# **CONFIRMED MINUTES**

**SPECIAL MEETING OF COUNCIL**

**9 MARCH 2020**

#### 7.1.1 PROPOSED SERVICE COMMERCIAL STRUCTURE PLAN - LOT 3082 CABLE BEACH ROAD EAST

Figure 2: Spatial Representation of Bushfire Management Plan and Actions - Stage One

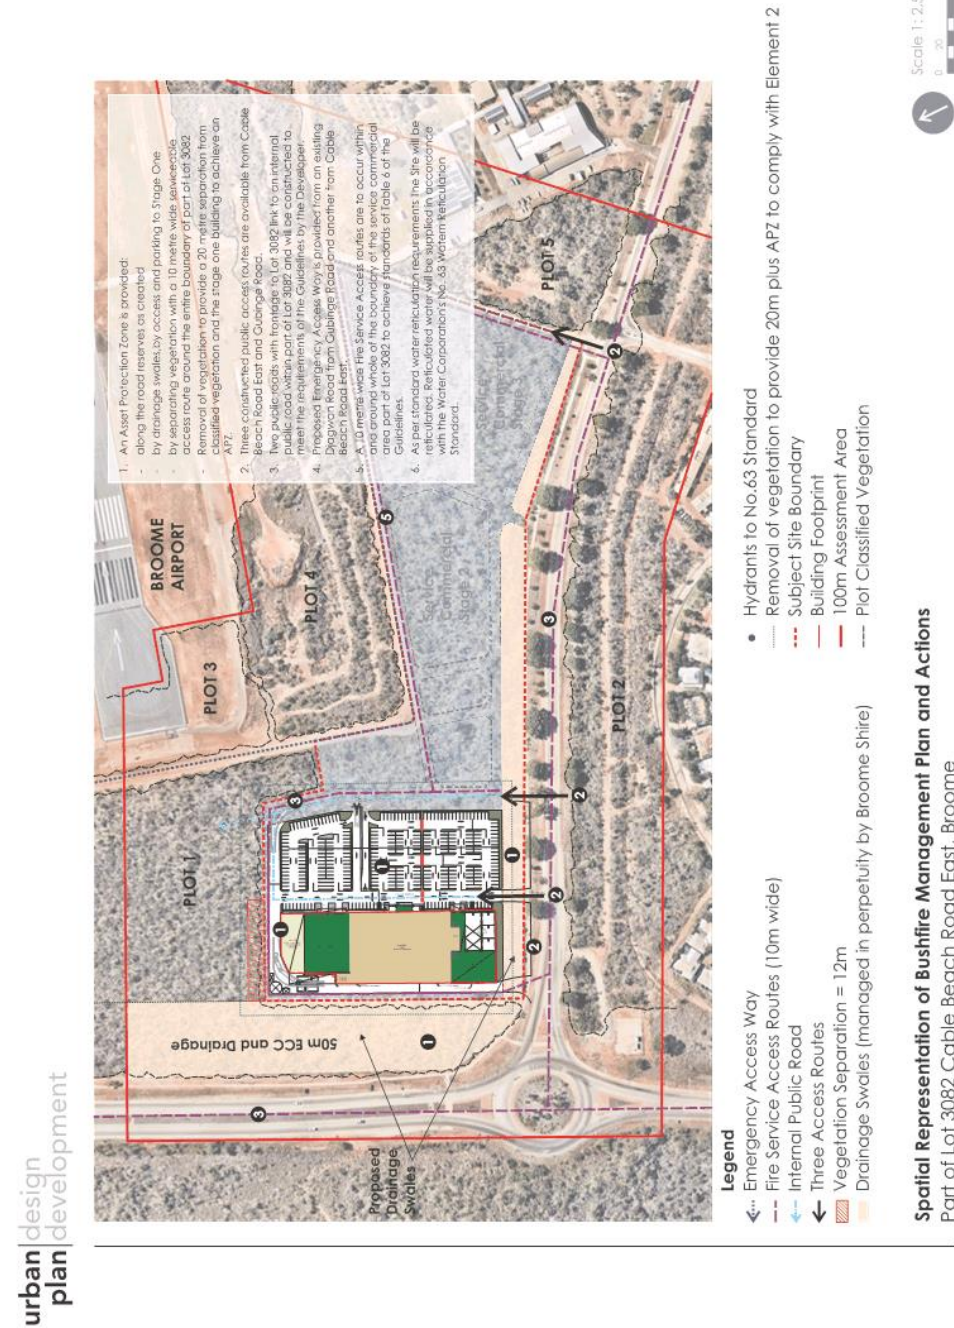
<p><b>Assessment</b> Figure 2 of the BMP depicts areas outside the site boundary as indicative APZ's. Bushfire management strategies should be achievable within the subject lot boundary. There is no mechanism to enforce clearing and maintenance of the vegetation within the adjoining areas in perpetuity.</p> <p><b>Action</b> Modification required.</p> <p>d) <b>Issue</b> BAL Contour Map input</p> <p><b>Assessment</b> The indicative BAL ratings cannot be validated. The inputs (i.e. slope/actual separation distances/vegetation classification) need to be included in the BMP to demonstrate the methodology applied to determine the BAL outputs within the Contour Map. This would generally be provided in a table. The BAL contours should extend from all areas of classified vegetation.</p> <p><b>Action</b> Modification required</p> <p>Policy Measure 6.3 c) Non-compliance with the bushfire protection criteria</p> <p>e) <b>Issue</b> Location &amp; Siting and Design</p> <p><b>Assessment</b> A1.1 &amp; A2.1 – not demonstrated The BAL ratings applied cannot be validated as described in the table above.</p> <p><b>Action</b> Modification to the BMP required.</p> <p>f) <b>Issue</b> Vehicular Access</p> <p><b>Assessment</b> A3.1 – Two access routes The Policy requires that two vehicular access routes are provided, both of which connect to the public road network, providing safe access and egress to two different destinations. The BMP identifies that the subject site has access to Cable Beach Road East, which provides a connection to two different destinations, which demonstrates compliance with A3.1. Therefore, it is unclear why the BMP and referral documentation refers to both an Emergency Access Way and a Fire Service Access Route (FSAR).</p> <p><b>Action</b> Comment.</p> <p>g) <b>Recommendation</b> – not supported modification required</p> <p>The BMP does not adequately address the policy requirements of SPP 3.7 and the Guidelines.</p> <p>DFES has assessed the structure plan and accompanying BMP and has identified several issues that need to be addressed prior to support of the proposal (refer to the tables above).</p>

3.	Vegetation Management		<p>Figure 2 of the BMP depicts areas outside the site boundary as indicative APZ's. Bushfire management strategies should be achievable within the subject lot</p>	BMP to be updated to address DFES comments.

No.	Clause	Currently Proposed	Reason	Modification
	(Figure 2 of the BMP)		boundary. There is no mechanism to enforce clearing and maintenance of the vegetation within the adjoining areas in perpetuity.

Figure 2: Lot Swale Diagram

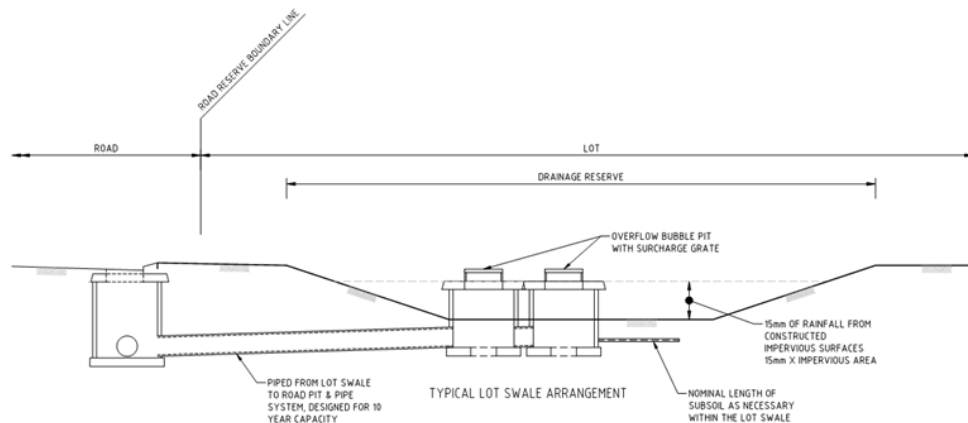
9.	LWMS - Figure 2 (page 11, figure 2)		Clarify whether figure 2 can be improved by avoiding overflow bubble up pit, and pit and pipe drainage system of road reserve. Lot swale can be designed just enough to manage runoff generated by small rainfall event. Provision can be made to have overland flowpath/sheet flow of runoff from lot swale to road side swale for the event greater than small rainfall event (page 11, figure 2).	LWMS to be updated to reflect DWER comments.
